24/00161/FUL

Construction, operation and subsequent decommissioning of a renewable energy park comprising ground mounted Solar PV with co-located battery energy storage system (BESS) at the point of connection, together with associated infrastructure, access, landscaping and cabling.

Land West Of Bradmore Road And North Of Wysall Road Land West Of Wysall Wysall.

## Appendix 1

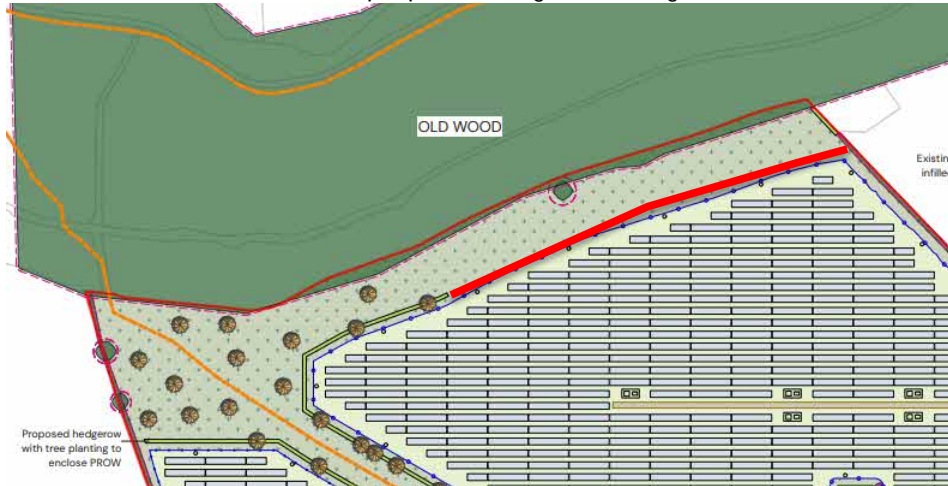
Recommendation 1 -continue proposed hedgerow along fence line of the northernmost solar array

Recommendation 2 -Grassland (meadow linkages improved) across farmland between northern and southern parcels

Recommendation 3 – strengthening north south orientated woodland linkages (between Kingston Brook to bunny Wood, via Copses and proposed hedgerow planting along PROW) along western boundary
